3.0 ERRATA TO THE DRAFT EIR

This section shows the revisions that have been made to the July 2007 Draft EIR for the Bonny Doon Limestone Quarry Boundary Expansion Project and Reclamation Plan Amendment Draft EIR. Revisions have been made in response to comments received on the Draft EIR.

Figure 38. Sensitive Receptors

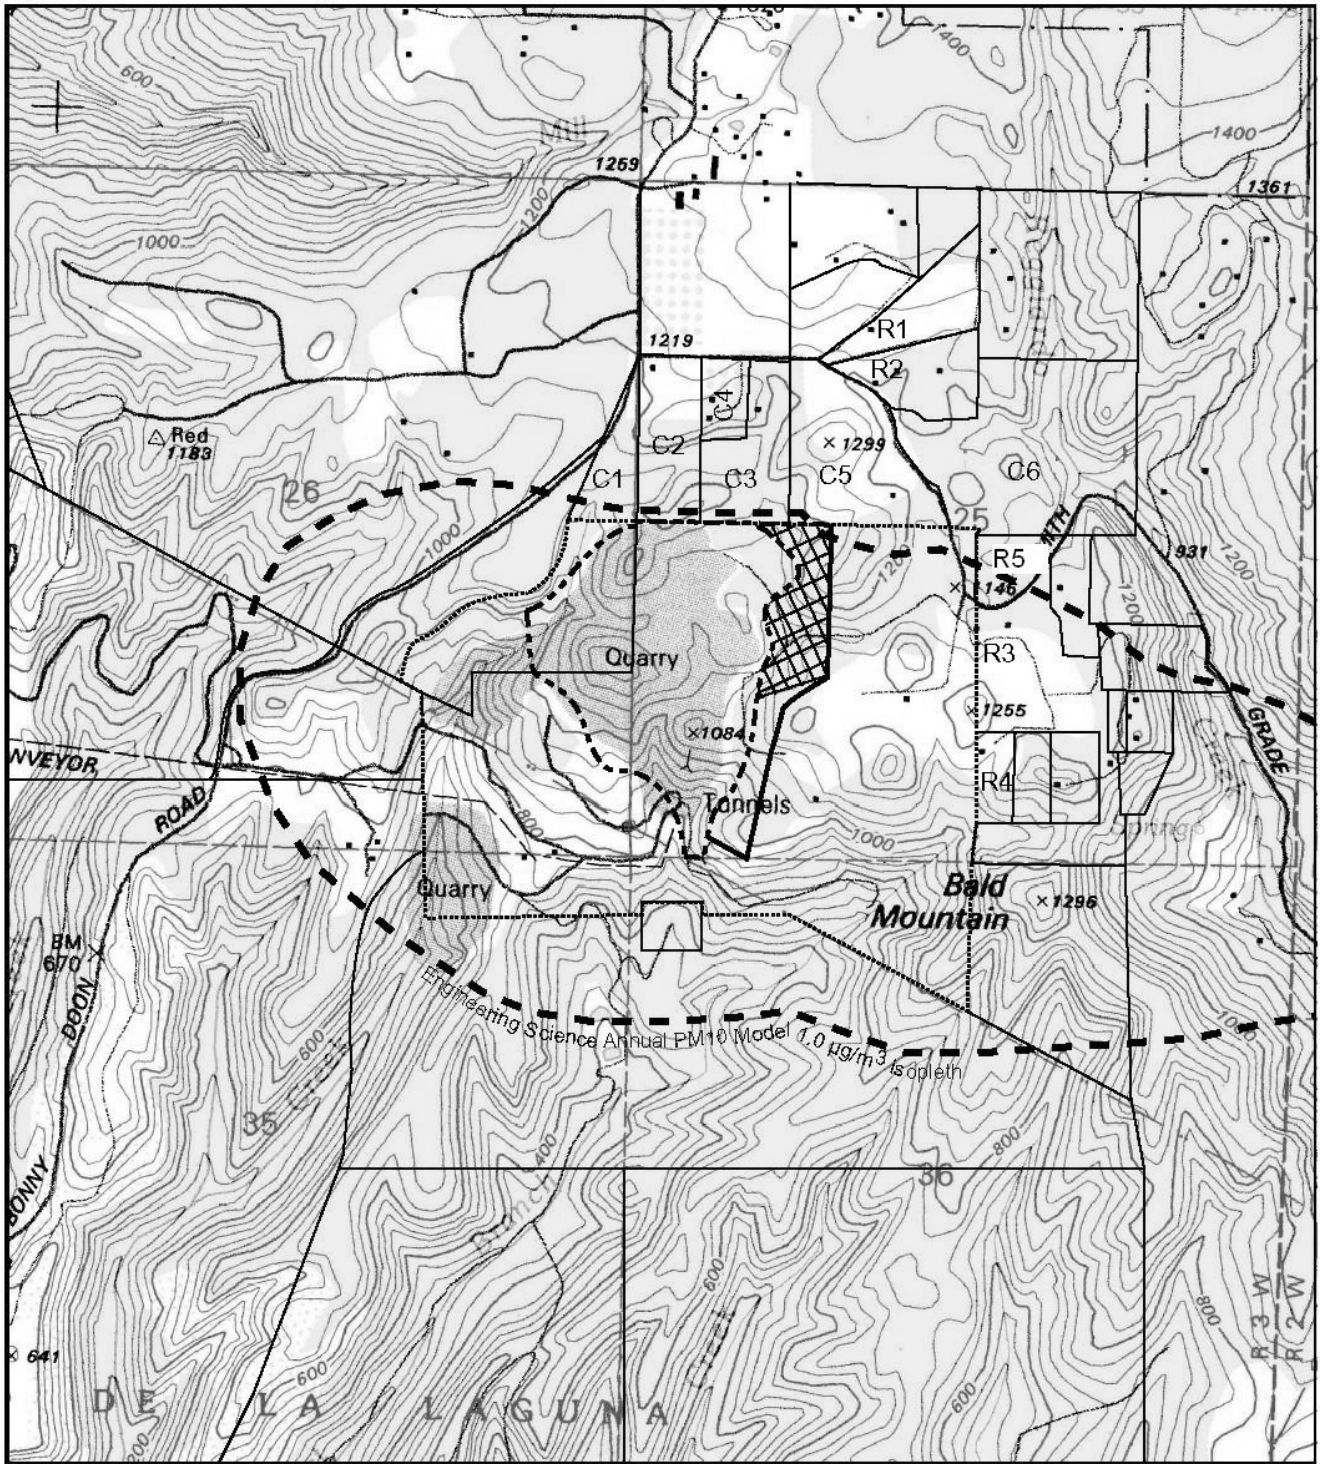
~~Five~~ Four other residences within 2,000 feet of the Boundary Expansion Area are identified on the proposed mining plan and shown in Figure 38. These residences are northeast and east of the current mining plan boundary.
